**City of Pembroke Pines
 Planning & Economic Development Department
 601 City Center Way 3rd Floor
 Pembroke Pines FL, 33025**

Agenda Date:	October 10, 2024	Application ID:	MSC 2022-0021
Project:	Bell's Funeral Home	Project Number:	N/A
Project Planner:	Laura Arcila Bonet, Planner / Zoning Technician		
Owner:	M & E 1 ENTERPRISES LLC	Agent:	Stephen Braggalla
Location:	8390 Pines Blvd	Commission District:	1
Existing Zoning:	B-3 (General Business)	Existing Land Use:	Commercial
Reference Applications:	SP 2017-06, SP 2015-26, SP 2015-23, ZV 2015-25, ZV 2015-26, ZV 2015-27, MSC 2014-28, ZV 2011-20, ZV 2011-21, ZV 2011-22, MSC 2010-16, MSC 2008-46, MSC 2004-57, MSC 2004-56, SP 2004-05, SP 2003-40, SP 2001-15, SP 2002-38, ZI 2000-01, SP 97-41, SN 94-10, SP 93-51, SP 90-13, SP 86-30, SP 86-05, SN 86-03, SP 84-37		
Applicant Request:	Architectural and signage modifications to an existing free-standing building		
Staff Recommendation:	Approval		
Final:	<input checked="" type="checkbox"/> Planning & Zoning Board		<input type="checkbox"/> City Commission

Project: *ELIJAH BELL'S FUNERAL HOME – BUILDING SIGNAGE & PAINT COLORS*
City Reference Number: *MSC2022-0021*

Re: MSC 2022-0021 (Bells Fune

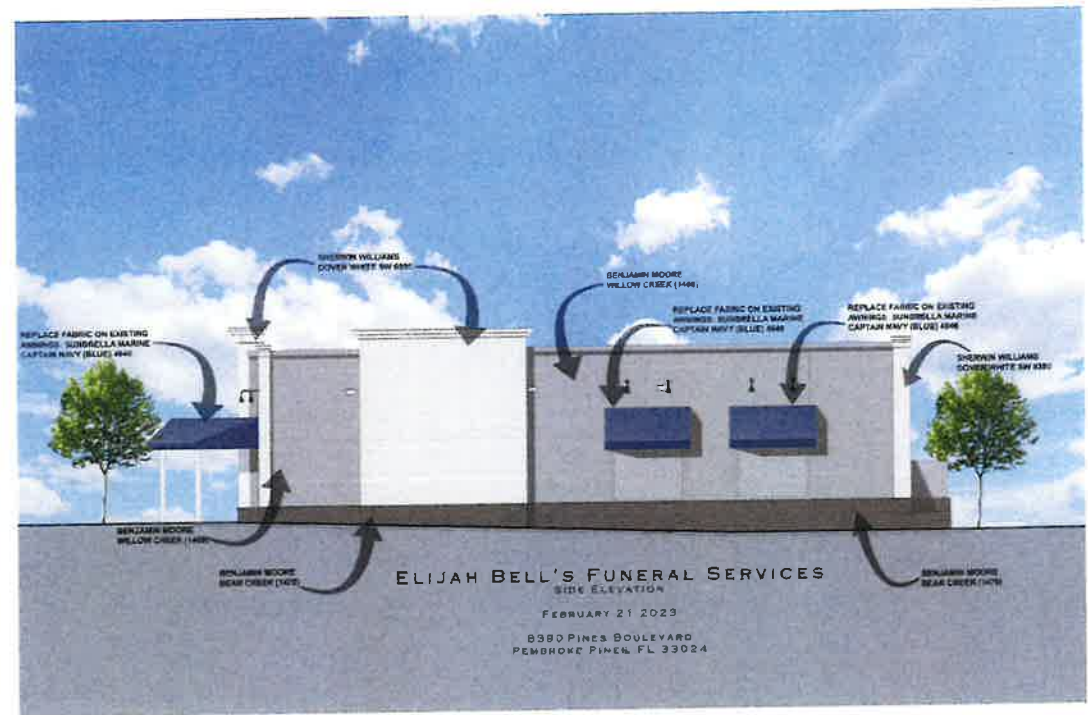
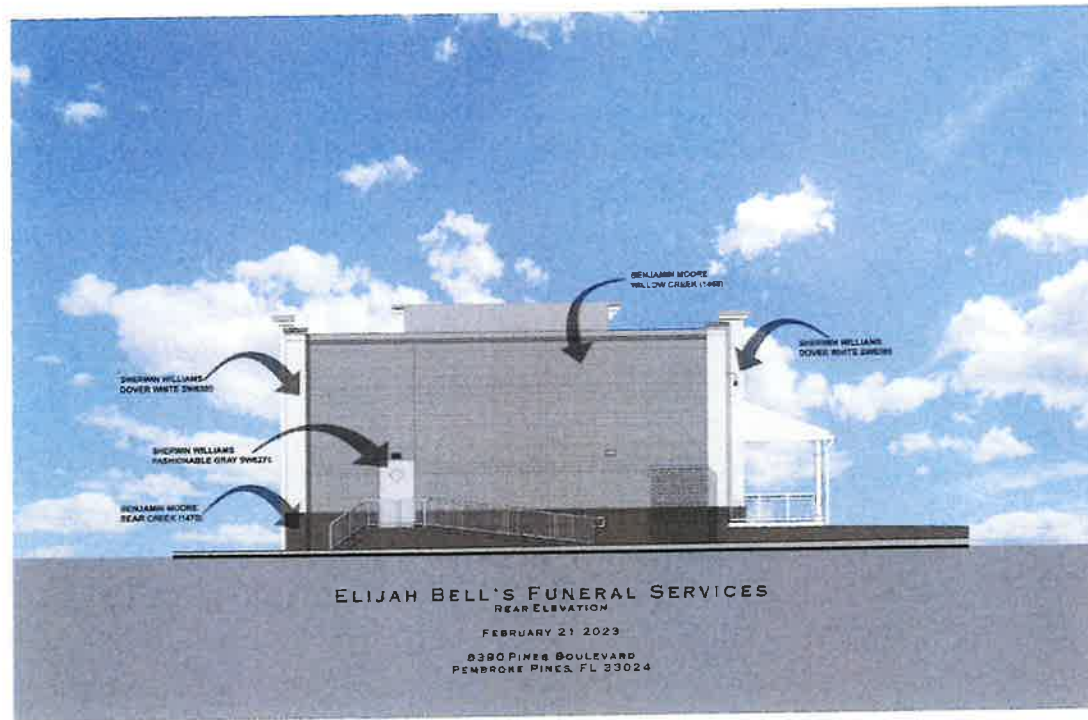
1. As part of DRC review a courtesy landscape inspection was performed for the above referenced project. As per previously approved landscape plans it seems as though a lot of landscaping is missing on site. See marked up plans attached and contact landscape planner to bring site back into compliance. Should no one contact Landscape team, a code violation will be issued.
